# HBU Fuel Accident Source Terms – Summary

## ACRS Briefing Nov 19, 2024

# High Burnup Fuel Source Term Accident Sequence Analysis

PEER REVIEW OF THE IN-CONTAINMENT SOURCE TERM STUDY FOR  
HIGH-BURNUP AND HIGH-ASSAY LOW ENRICHED URANIUM FUELS

# Iodine and Cesium Chemical Form

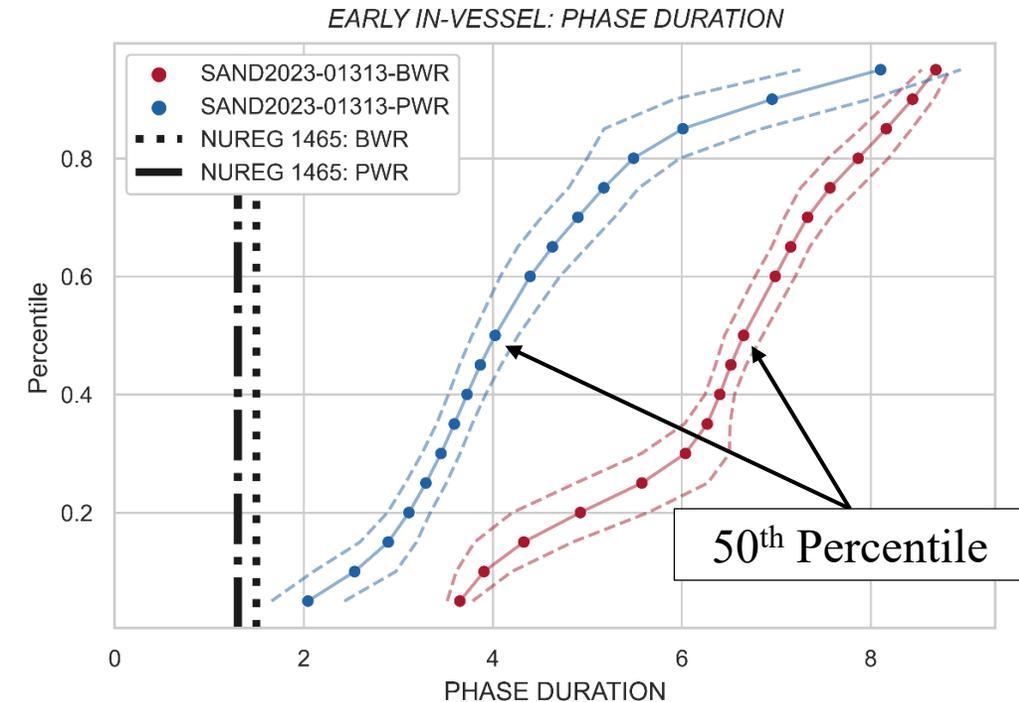
- Uncertainty in Iodine speciation persists despite experimental studies (FPT3, DF-4, and BECARRE)
- Fukushima Daiichi post-accident analyses confirm assumption that  $Cs_2MoO_4$  is dominant chemical form of Cs
- Recommended consideration of/validation against French CEA HBU VERDON tests

# In-containment Source Term Variability

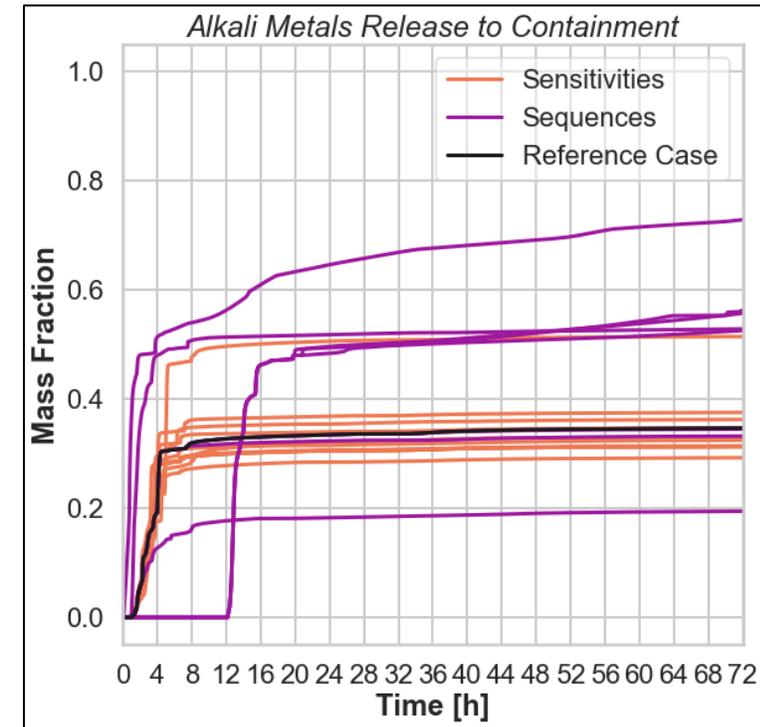
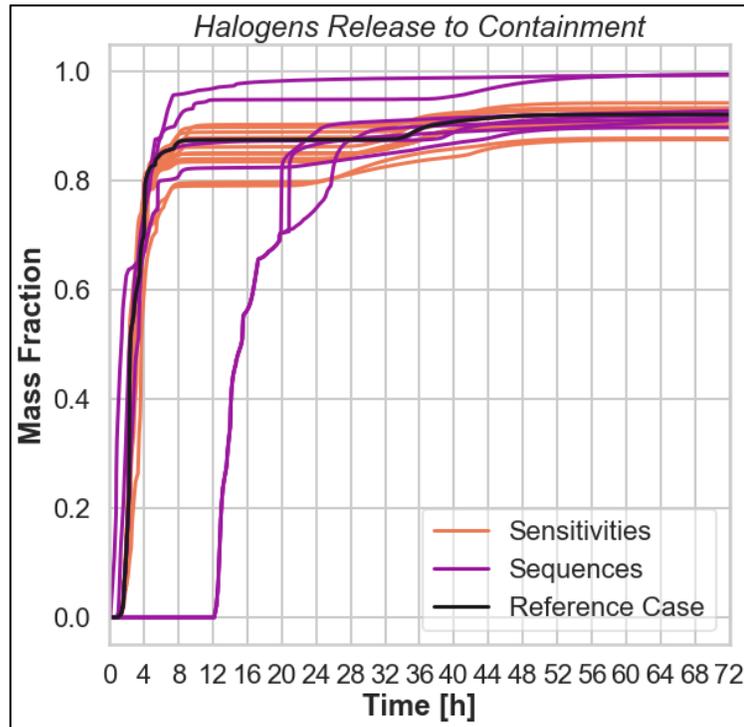
- Potential for combined effects of various sensitivity studies to be larger than separate effects  
*Nonlinear processes in severe accidents tend to limit amplification of response variability in multi-parameter sensitivity studies such that single scenario variability is less than variation across scenarios*

In-containment source term variation dominated by variation across sequences

# In-containment Source Term Variability

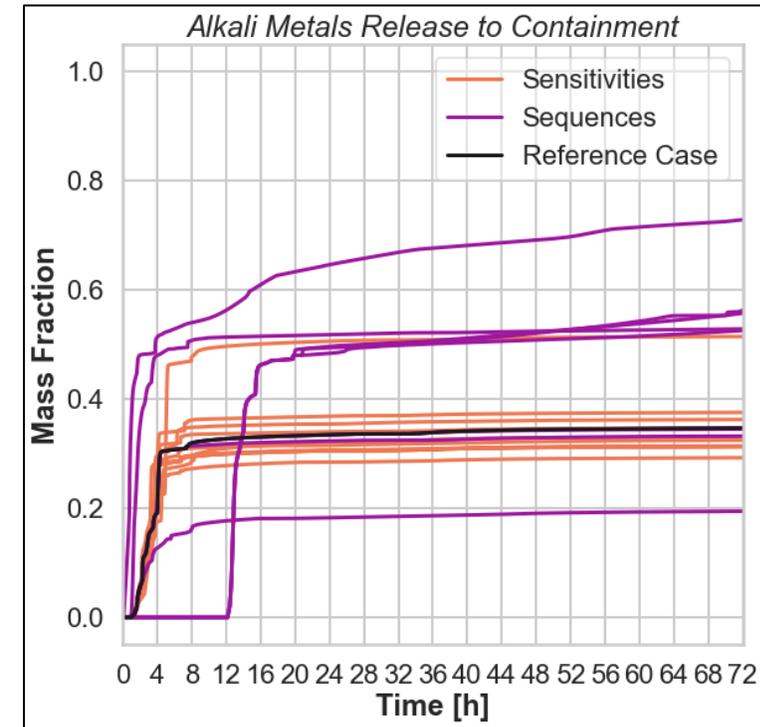
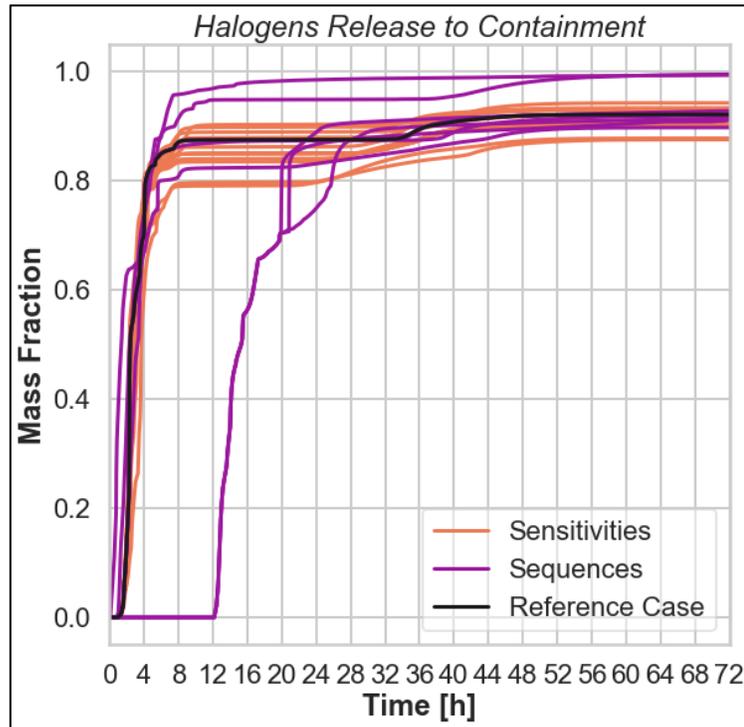
- Potential for combined effects of various sensitivity studies to be larger than separate effects  
*Nonlinear processes in severe accidents tend to limit amplification of response variability in multi-parameter sensitivity studies such that single scenario variability is less than variation across scenarios*

In-containment source term variation dominated by variation across sequences

# Fission Product Retention in Suppression Pools

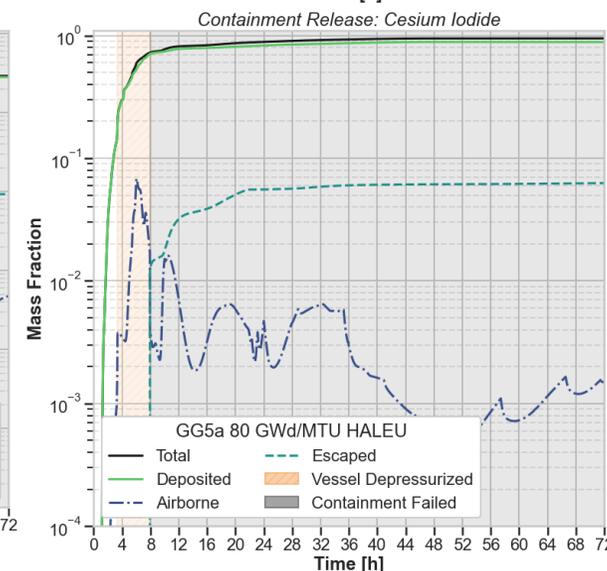
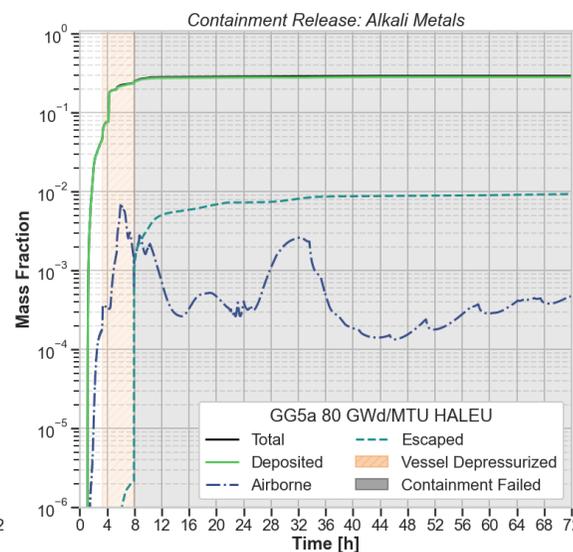
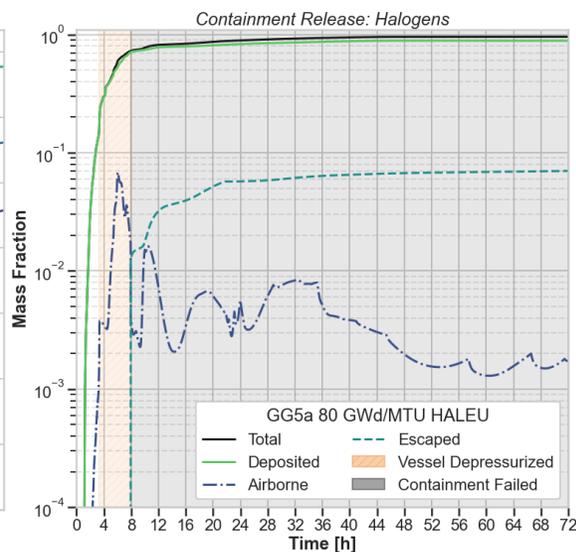
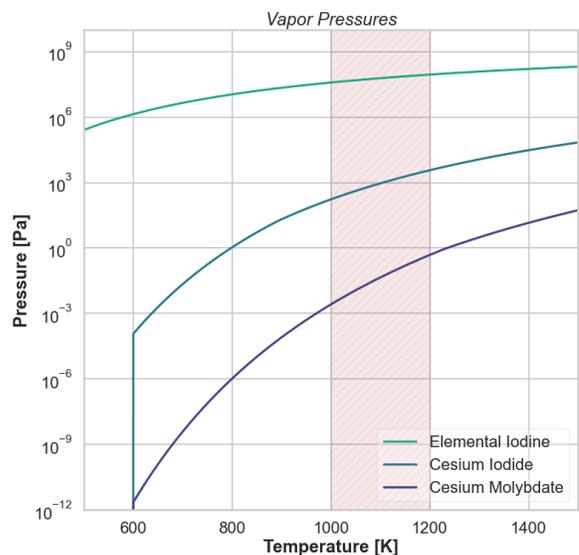
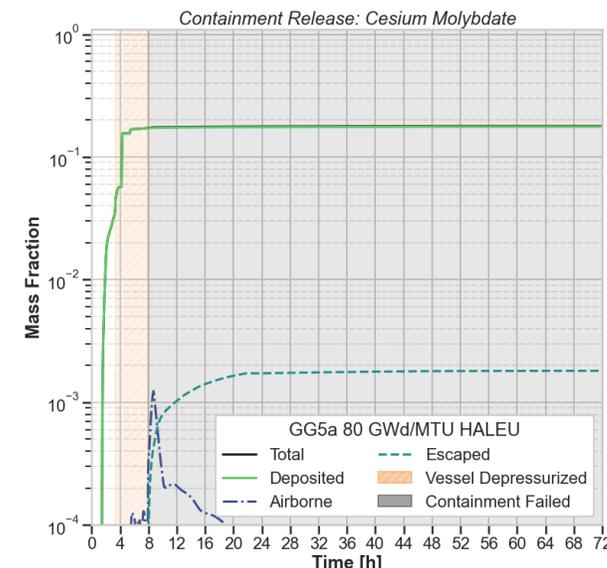
- In-containment source terms should consider the impact of retention in suppression pools, especially for SBO scenarios that discharge directly into the suppression pool
- Estimates of retention in suppression pools provided in SAND2023-01313 could be used in regulatory guidance to establish suppression pool decontamination factors
